MINATO MARU / ENGINE ROOM H1

JS127-ER-H1-03 | CAD implementation amendment | 31 October 2026

CURRENT MODEL SURVEY + ENGINEERING REVIEW

Deck-height coordination / new ladder and protected working space

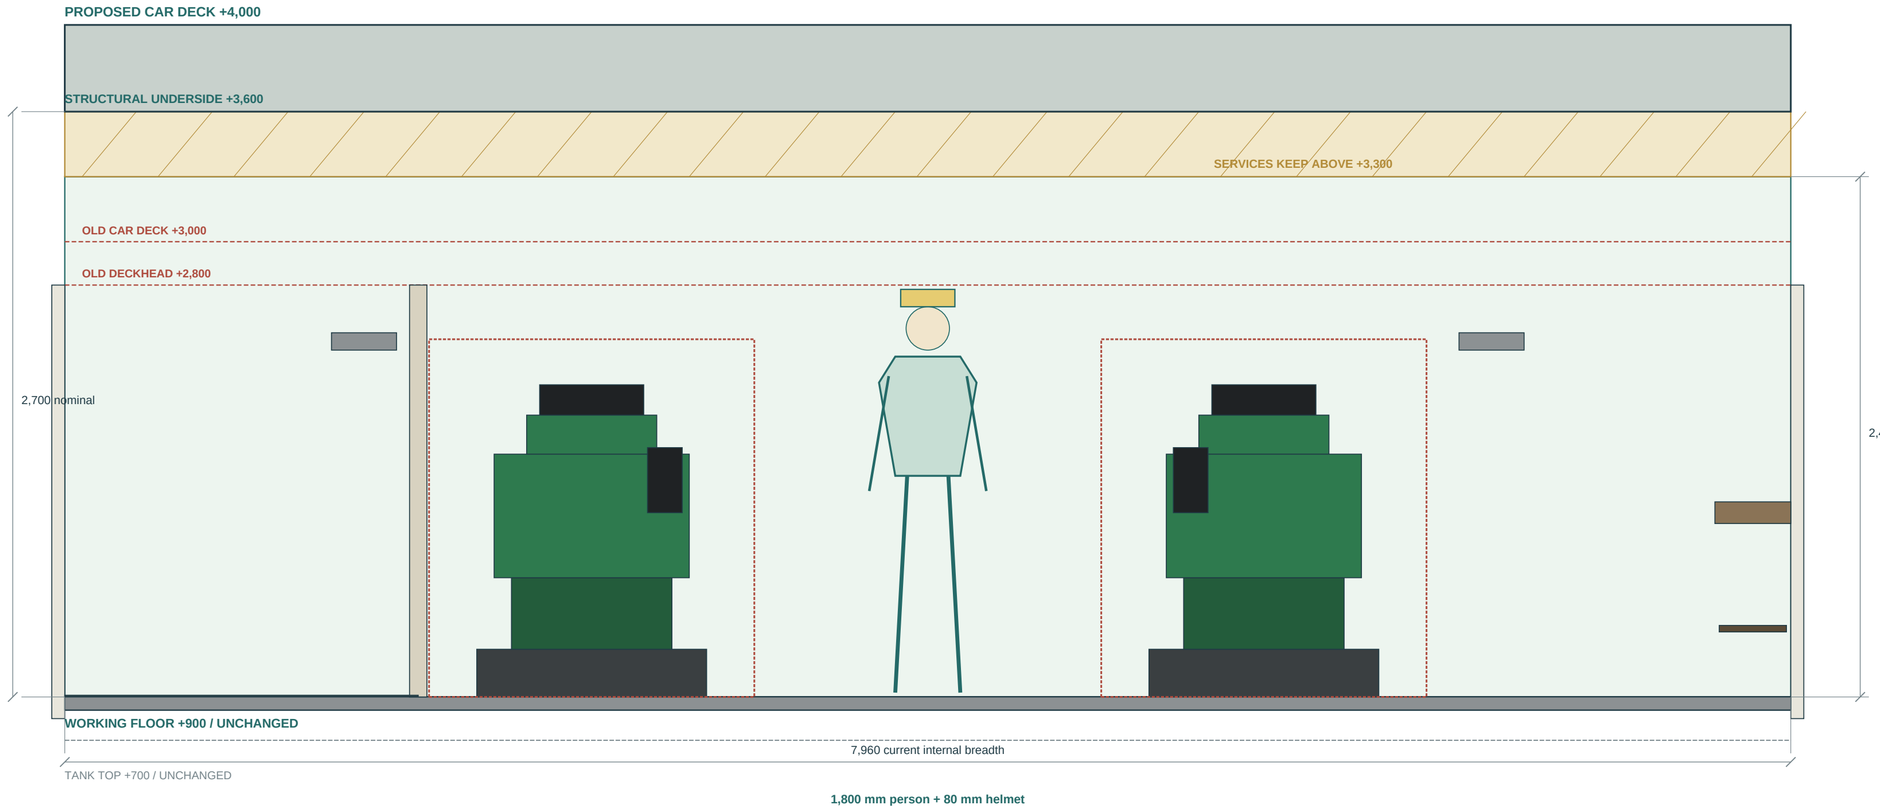
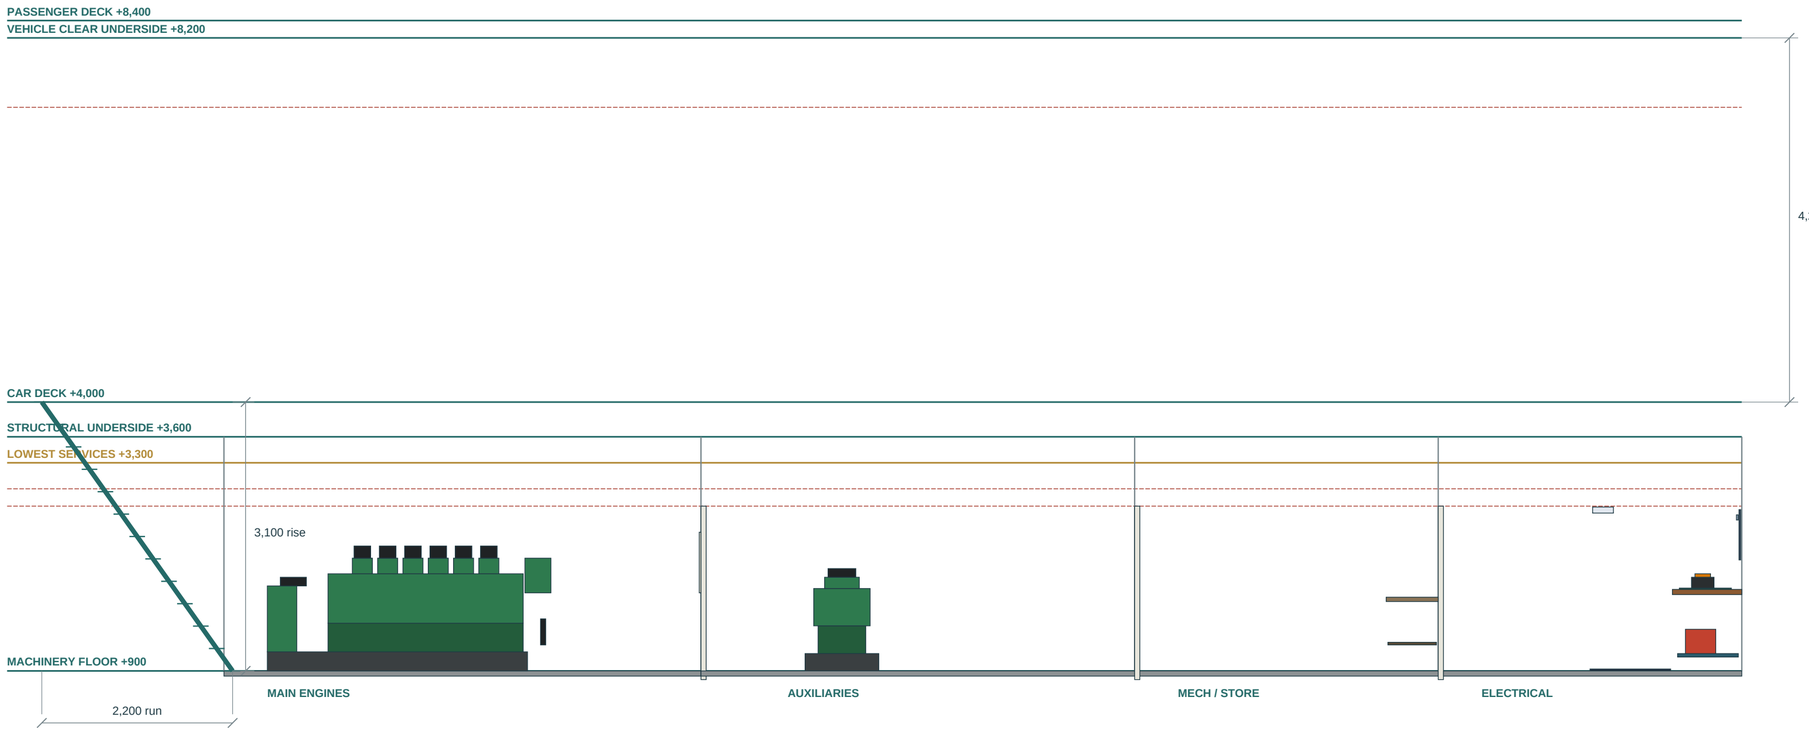
The room becomes 800 mm taller at the structural underside. A separate 400 mm vehicle-deck structural reservation makes the proposed car deck 1,000 mm higher. Raising the decks above by the same 1,000 mm retains the existing vehicle and accommodation clearances.

No ducking in designated standing and working areas. Pipes, trays, valves, handles and insulation must stay outside the clear-height envelope.

400 mm is a structural planning reservation, not a calculated beam size. If selected structure or services need more depth, increase deck elevations; do not consume the 2,400 mm clear space.

A uniform raised vehicle deck is used to avoid a local machinery hump in the car lanes. Passenger and bridge decks, casings, access, exhausts, vents, ramp hinge/landing arrangements, gangway landings and vertical services need to follow the new levels. Hull breadth, machinery floor and shaft lines are retained as design constraints.

Raise car deck and upper decks by 1,000; raise lowest machinery deck structure by 800. The extra 200 increases the former 200 mm deck envelope to a 400 mm reservation.

Preserve vehicle clear height. Revised overall height, freeboard, lightship/KG, windage, ramp slope, berthing and structure require verification before any game build.

A 3,100 rise with the old 1,600 run would be 62.7 deg. The 2,200 run gives 54.6 deg. A longer flight and landing must be modelled, not a stretched steep ladder.

New machinery volume affects fire suppression and ventilation. Recalculate protected volumes, fan duties and exhaust support. Do not reuse the old 190 m3 CO2 basis.

Baseline accepted paths are not accepted against H1 headroom. Move route design to the new overhead zone and recheck ownership, valves, supports, penetrations and escape.

MINATO MARU / H1 LADDER AND TOP LANDING

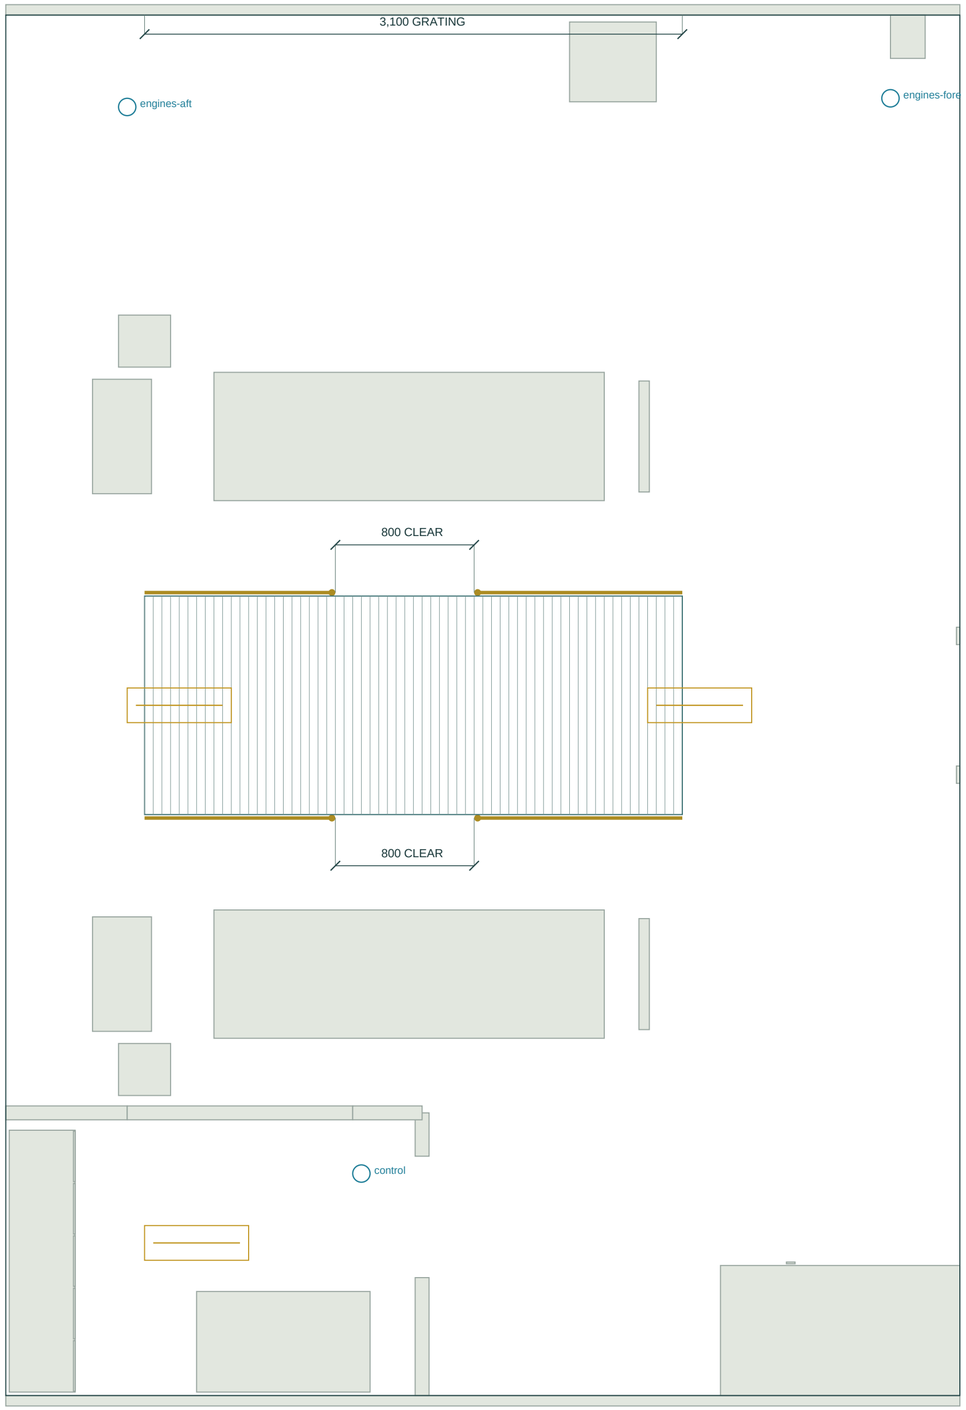
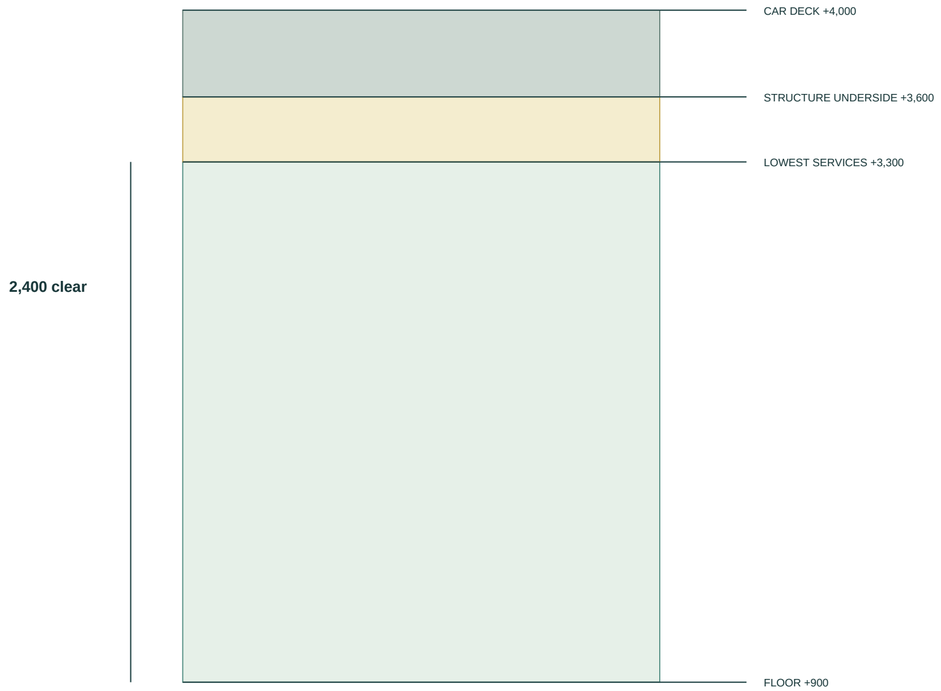
The longer ladder requires a landing behind its head. Relocate the casing P side door; do not enter mid-flight.

New side-door opening X5,300-6,400; clear longitudinal opening 1,100.

Top landing X5,250-6,400: 1,150 long, above the same +4,000 car deck.

Ladder head X6,400; foot X8,600; rise 3,100; nominal angle 54.64 degrees.

MINATO MARU / H1 BOARDING COORDINATION

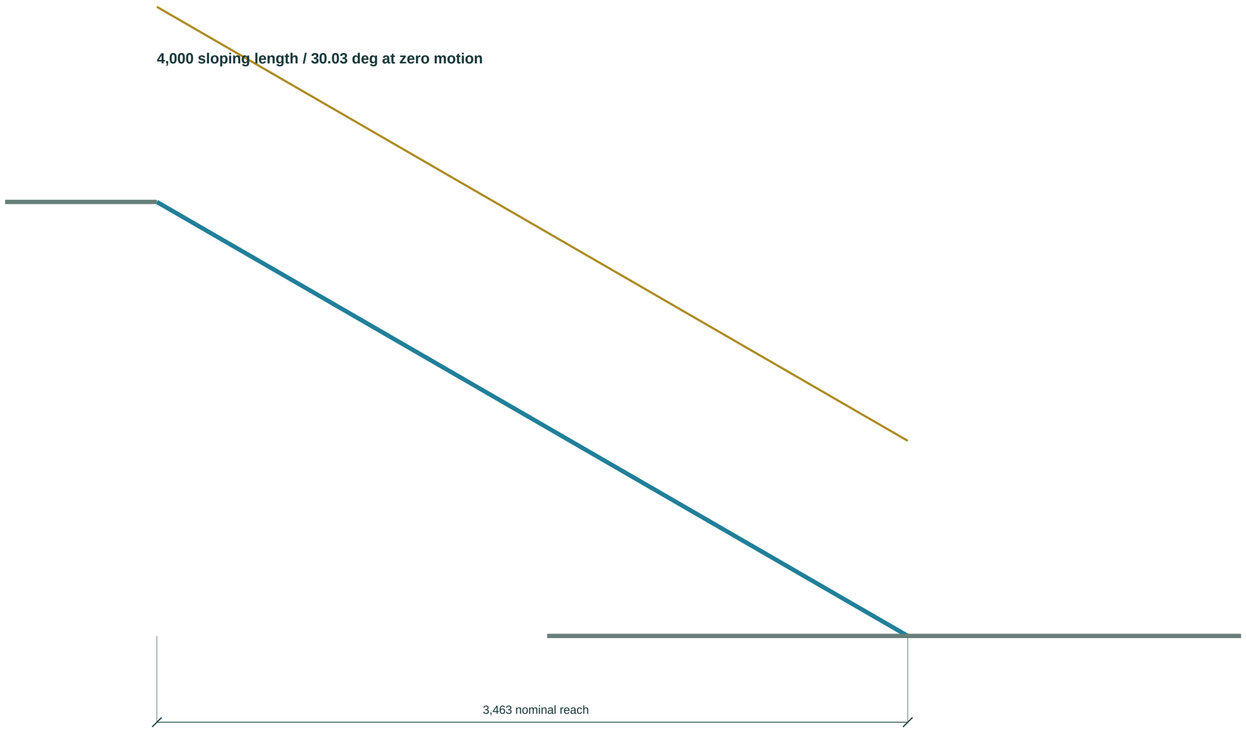
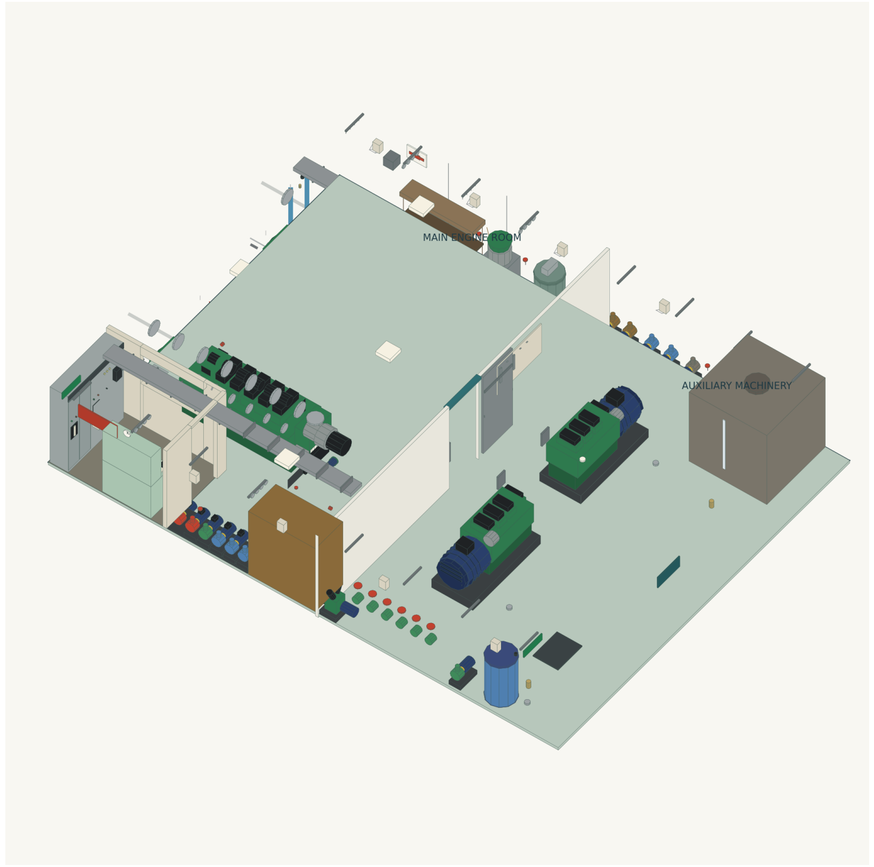
Raised vehicle deck: extend the boarding gangway rather than leave an unsupported step from the pier.

Gangway: 4,000 long x 1,400 gross width; retained side handrails.

Fold upright under passenger deck; 4,200 clear zone reserves 200 margin.

New length maintains about 30-degree nominal boarding inclination.

Main engine room / equipment and working clearances

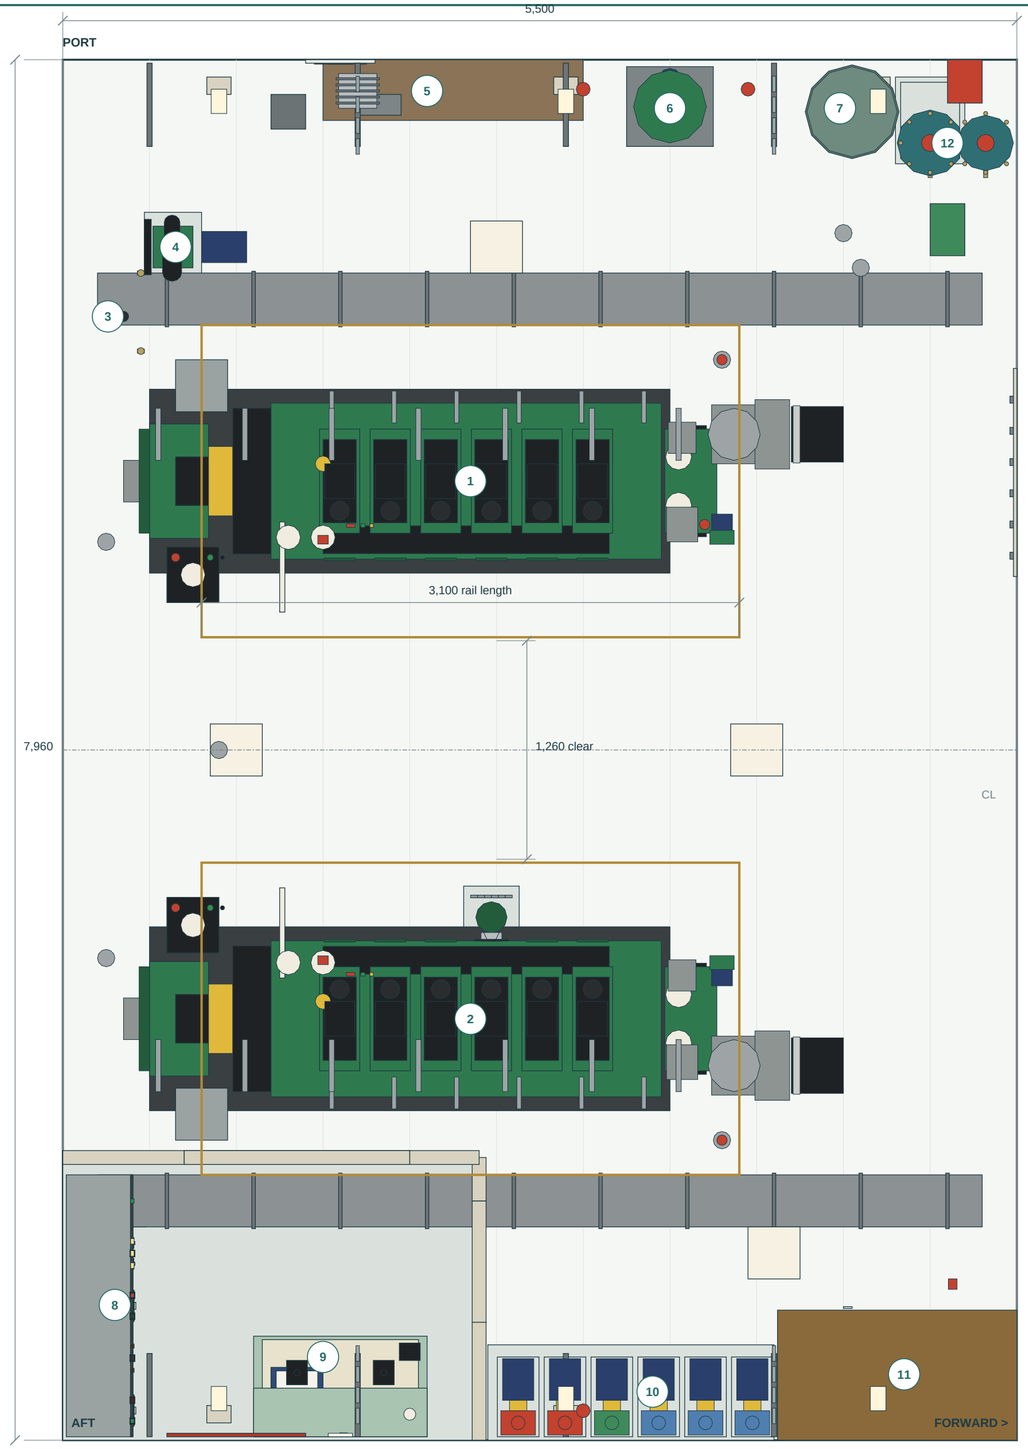
Current bedplates X=9,000-12,000; centres Y=+/-1,550. Actual fittings are projected from source; manufacturer installation dimensions remain unverified.

Two 150 L receivers and compressor No.1 aft to port. Receiver reliefs, drains, certified start capacity and complete piping still need detail.

Workbench, fuel purifier and oily-water separator. Keep machinery opening and filter/basket withdrawal space; the picture alone does not prove service access.

MSB aft, engine console and log desk along the side. Current booth has one modelled doorway; protected independent escape is unresolved.

Service tank remains forward starboard. Both sea-water suctions/strainers must remain accessible. Tank, hot exhaust and switchboard routes must be coordinated.

Closed yellow rail loops currently surround both engines. No gate is modelled; a maintainable machine cannot rely on climbing a rail. A correction must retain guarded edges and provide deliberate service access.

Auxiliary machinery room / generators and service plant

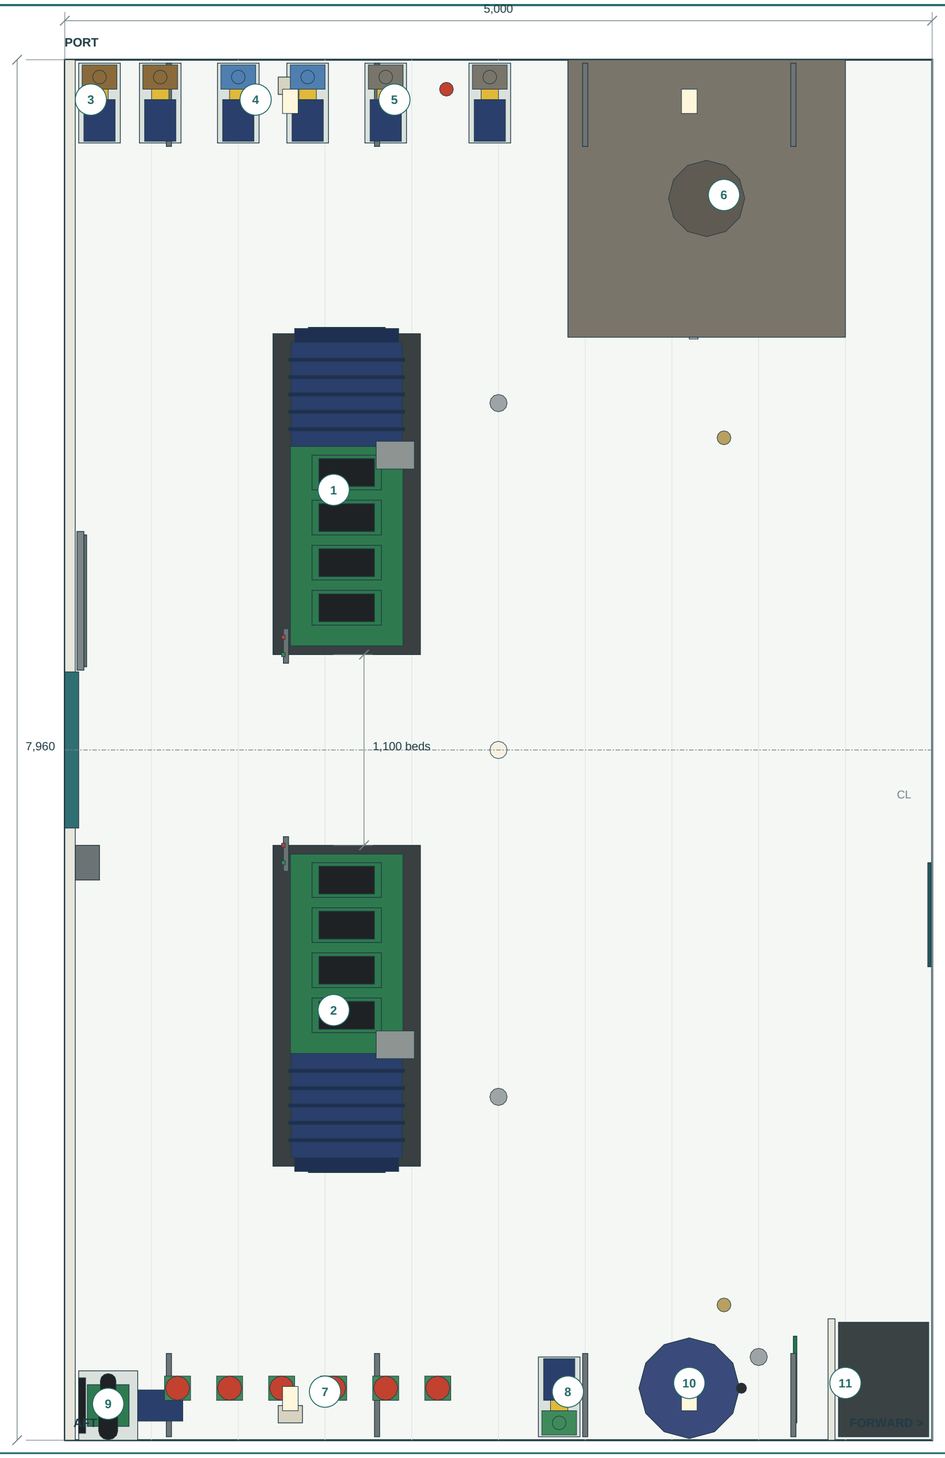
Two separate pumps remain. Dedicated suction/discharge interfaces and control/bypass arrangements need the unpublished fuel C1 design to be reviewed.

Ballast manifold, ballast pump, compressor No.2 and 300 L hydrophore vessel. Access to valve spindles, motor withdrawals and pressure-vessel inspections remains a hold.

A 700 mm-wide model trunk is drawn. It is an existing representation, not a proved protected exit to a safe deck. Route and fire-boundary details must be completed.

Door at X=14,000: 800 mm nominal wide. Door at X=19,000: 750 mm nominal wide. Do not route machinery removal through these openings unless the dismantled item and rigging fit.
